APOPKA DEVELOPMENT REVIEW COMMITTEE MEETING AGENDA

August 2, 2023 9:00 AM

1. Kelly Park Storage - Rezoning/Master Plan, 3rd Submittal

RE: Kelly Park Storage Property – Rezoning and Master Plan, 2nd Submittal

05.23
MASTER DEVELOPMENT PLAN
Project no. 22245
Sheet number
2 of 2

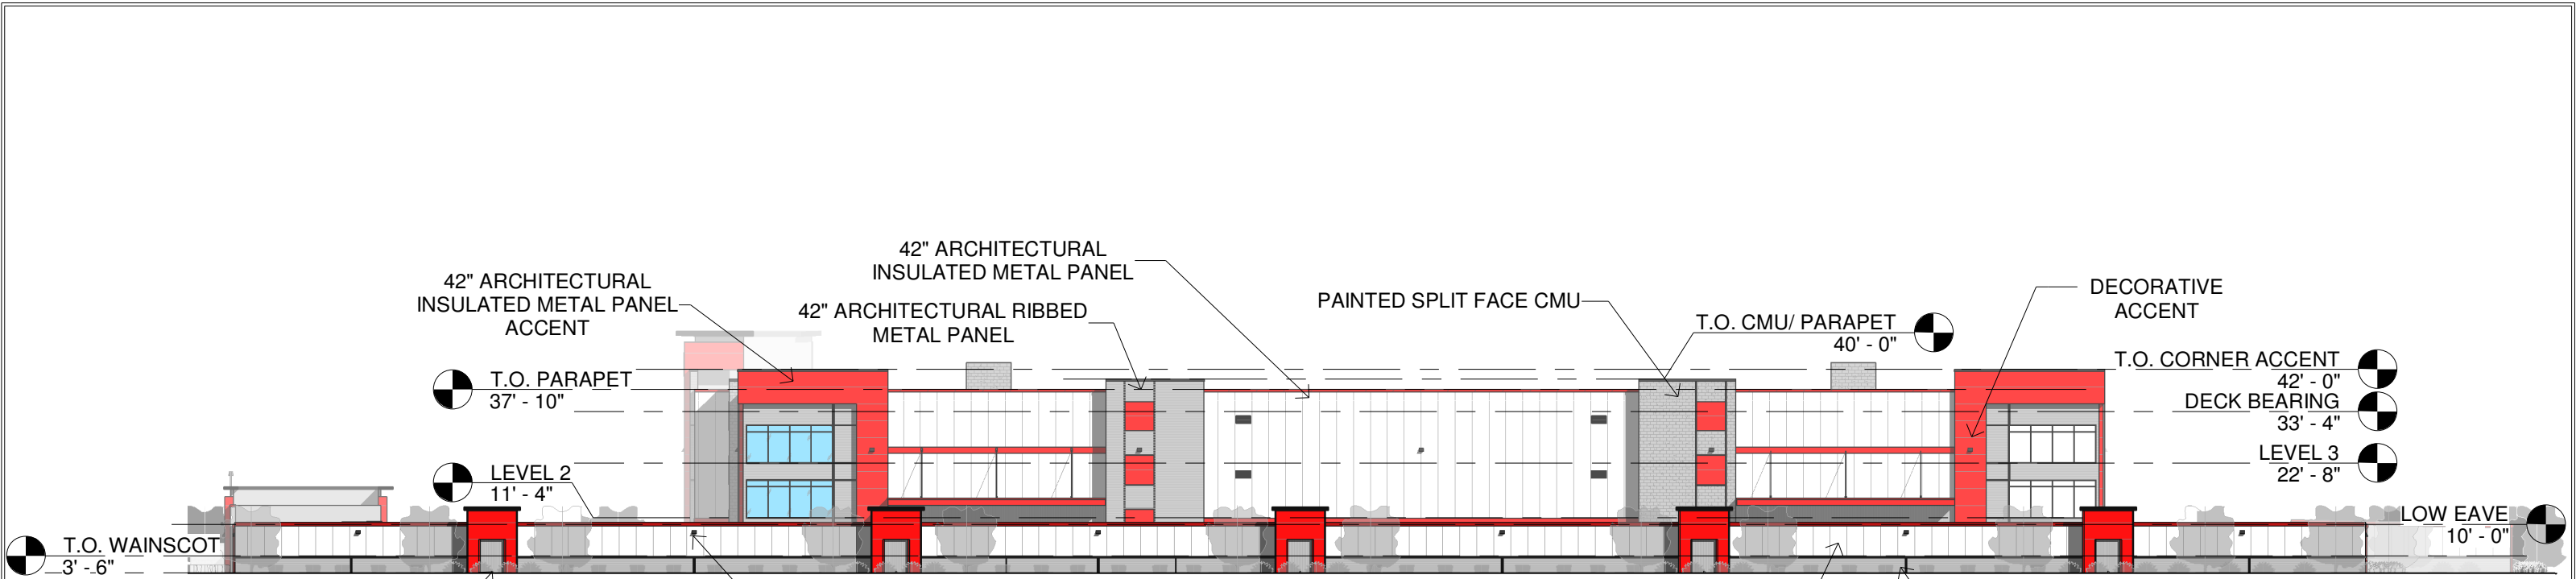
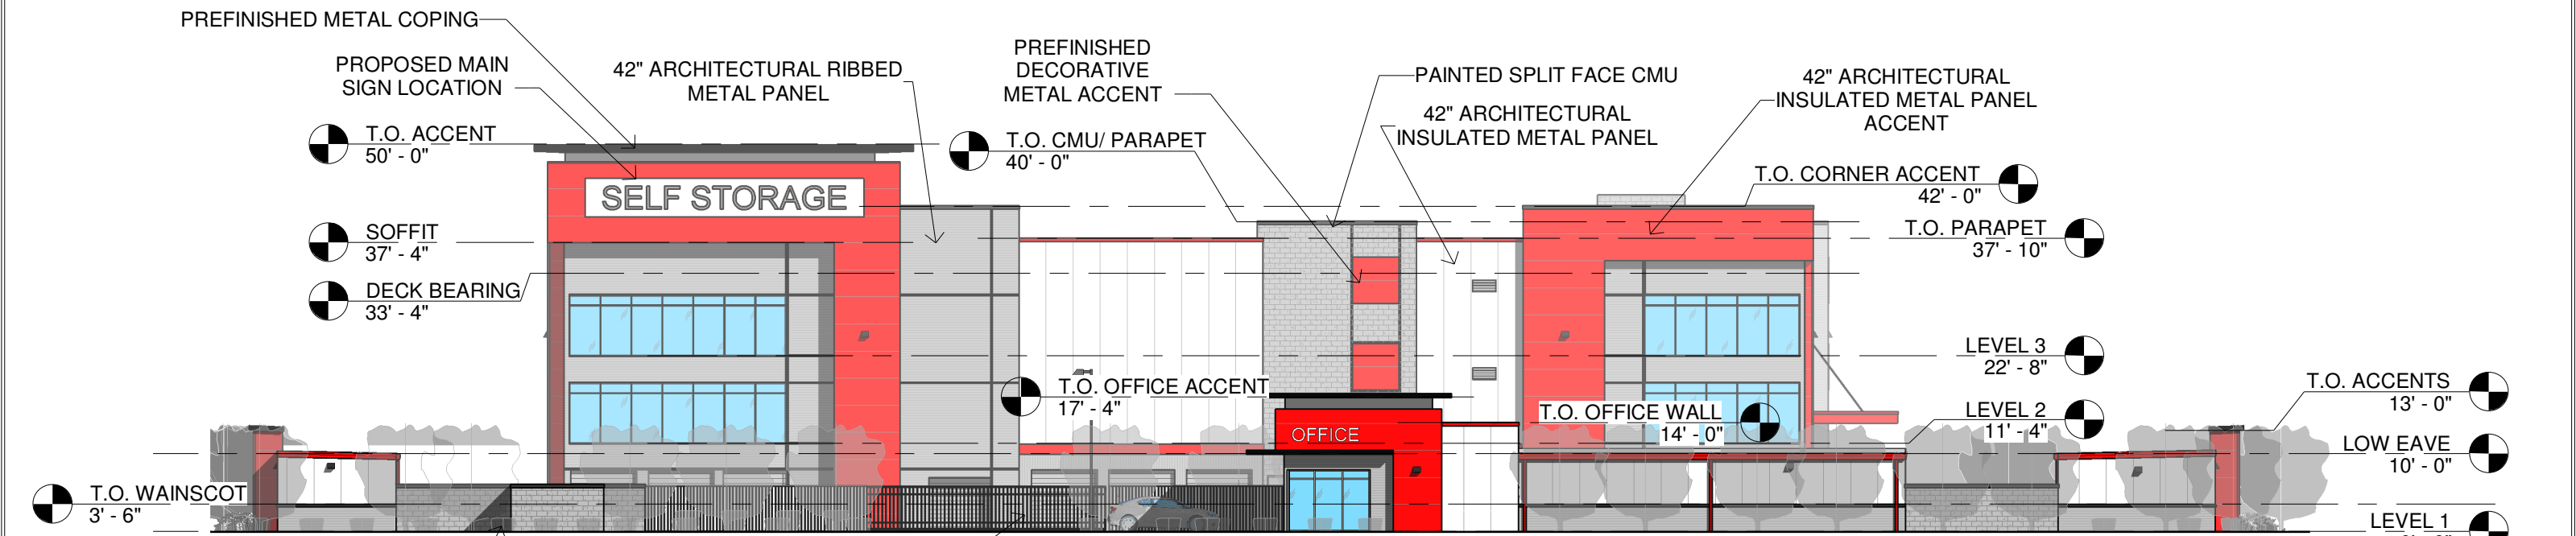
2. Provide a narrative on proposed use(s). More comments may be generated after this response is provided. Clarify if the gas station would include a car wash facility as an accessory use.

4. REPEAT COMMENT: The open space requirement for developments in the Interchange Overlay is 15%. Refer to Section Q of the Kelly Park Interchange (KPI) – Form-Based Code. Label on the Master Plan the proposed open space. Said section includes a list of acceptable open space.

5. Correct spelling of Effie Drive.

6. REPEAT COMMENT: Label the proposed location of the off-street parking area.

7. REPEAT COMMENT: There is a proposed mixed-use development proposed west and south adjacent of this project. Coordinate with the application for Kelly Park Crossings – Master Plan for cross-connection.

8. REPEAT COMMENT: Note that Effie Drive may require improvements that will result in road construction south of Kelly Park Road. Right-of-Way dedication may be required. Please contact Pam Richmond, Transportation Coordinator, at 407.703.1684 or prichmond@apopka.net for more information. Clarify if discussion with the Pam has been established in reference to road improvements and cross access.

Response: The narrative is on the Master Development site plan. The gas station does not have a car wash.

Response: See 'SITE INFORMATION' on the plan, item 5 for revised open space calculation.

Response: Effie Drive has been spelled corrected.

Response: The off-street parking areas are located in a bubble with a delta 6.

Response: See delta 7 located on the west side of the plan. A cross-connection between Wyld Oaks and the Self Storage will not work because of the median in the middle of the road.

Response: I had a phone call with Pam Richmond to discuss the cross-access (see item 7) and the improvements requiring dedicating 10' of ROW on Effie Drive and 30' on W. Kelly Park Road. See delta 8 for the location of the notes at both areas.
